Access Compliance Report

Public Rights-of-Way (Curb Ramps)

Intersection ID: 10016341	Main Street: UNIVERSITY_CITY_BV	Cross Street: N/A	Location: SW
ADA ID: A3D64BBE548C	Ramp Type: Perp	Initial Pass/Fail: Pass	Overall Compliance: No
Severity Score: 2.5			
Codes/Mitigation Info/Possible Solution		Field Measurements/Component Compliance

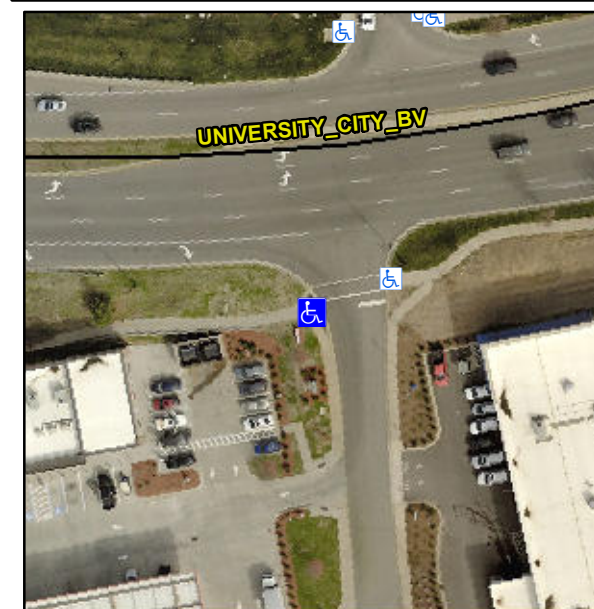
Possible Solutions:

**Remove & Replace Detectable
Warning System.**

PROW/ADA:

R305.1.4
